Accessibility Survey

Parking Structure

2nd Street and La Reina Avenue
Downey, CA 90240

Date of Inspection
12/21/2016

1st Floor, Accessible Space Next to Elevator

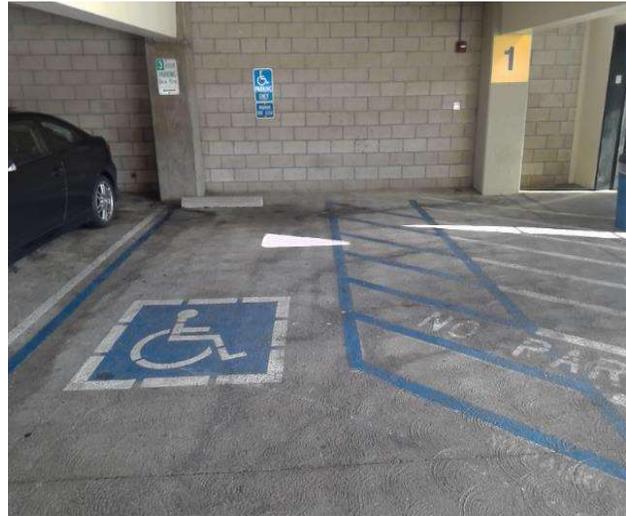
The bottom edge of the wall-mounted signage designating accessible parking is not at the required height.

On-Site Finding 42.62 inches

Remount the wall-mounted signage designating the accessible parking space so that it is installed at the required height. The sign shall be located so that it cannot be obscured by a vehicle parked in the space.

Recommendation At least 60.00 inches

1st Floor, West Wall, Left Accessible Space

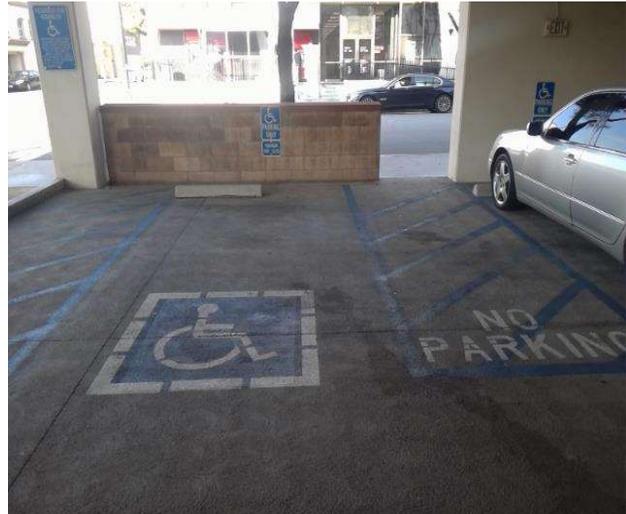
The bottom edge of the wall-mounted signage designating accessible parking is not at the required height.

On-Site Finding 15.00 inches

Remount the wall-mounted signage designating the accessible parking space so that it is installed at the required height. The sign shall be located so that it cannot be obscured by a vehicle parked in the space.

Recommendation At least 60.00 inches

Run 2 Floor Level Landing

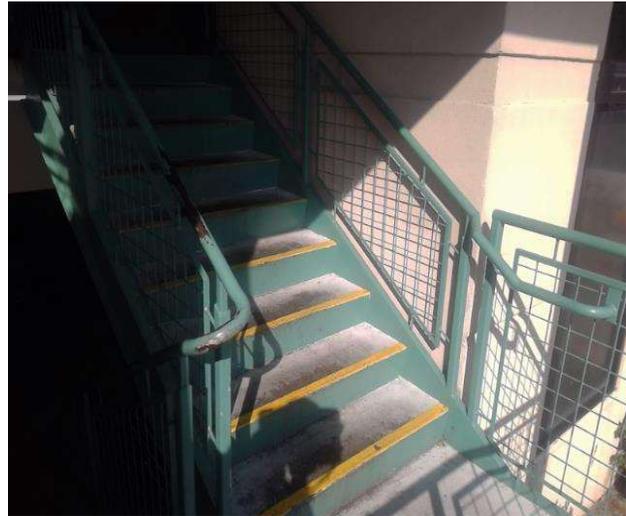
The stairs do not provide accessible signage stating the floor level and the upper and lower terminus of the stairway. The stairway provides access between two floor levels of the facility.

On-Site Finding None Found

Install signage at the required height above the finished floor on the wall adjacent to the latch side of the entry doorway stating the floor level and the upper and lower terminus of the stairway. The sign shall provide raised Arabic numerals and raised Grade 2 Braille symbols and shall comply with the finish and contrast requirements set forth. Signage should be located where a person may approach within three inches of the sign without encountering protruding objects or standing within the swing of the door.

1st Floor, West Wall, Left Accessible Space

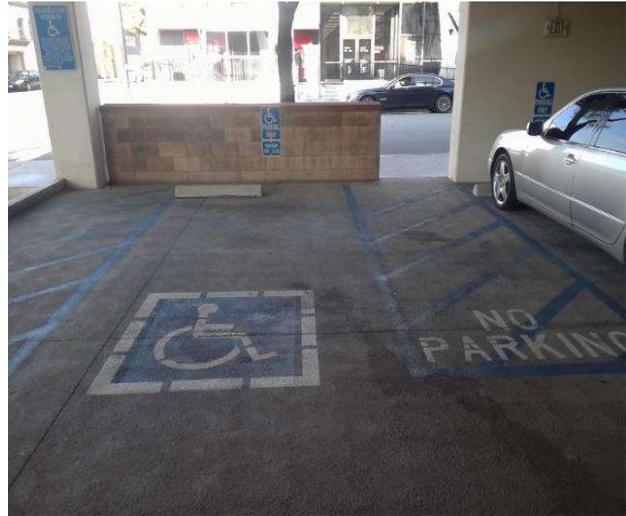
The access aisle does not meet the minimum required width.

On-Site Finding 58.50 inches

Re-stripe the access aisle to meet the minimum required width and length for the space type.

Recommendation At least 60.00 inches

1st Floor, West Wall, Left Accessible Space

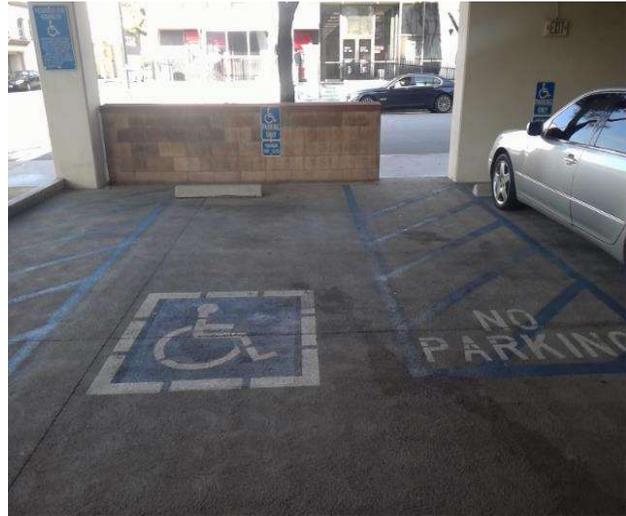
The accessible parking space does not meet the minimum requirements for width.

On-Site Finding 99.75 inches

Re-stripe the accessible parking space.

Recommendation At least 108.00 inches

1st Floor, West Wall, Left Accessible Space

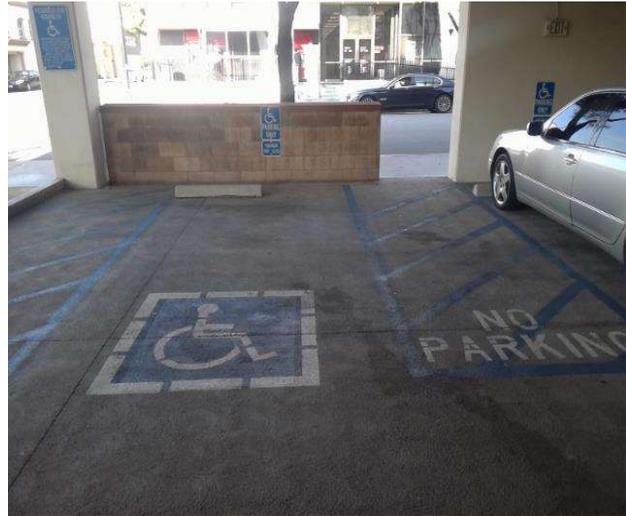
The accessible parking space provided in the parking lot does not meet the minimum requirement for length.

On-Site Finding 214.00 inches

Re-stripe the accessible parking space.

Recommendation At least 216.00 inches

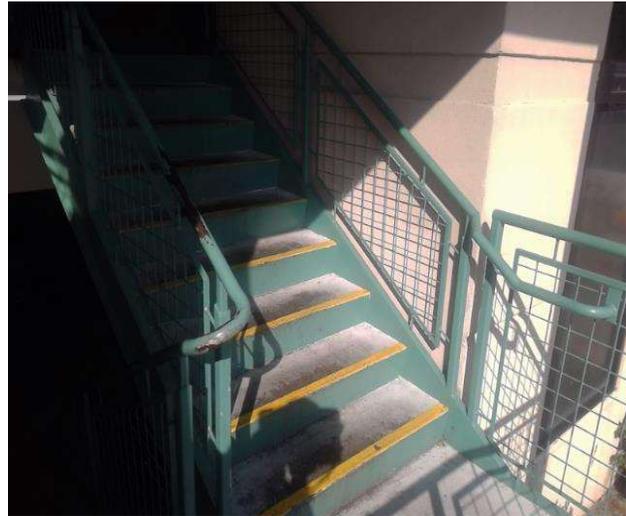
The bottom handrail does not extend the depth of one stair tread beyond the bottom step.

On-Site Finding None Found

Provide a compliant handrail extension.
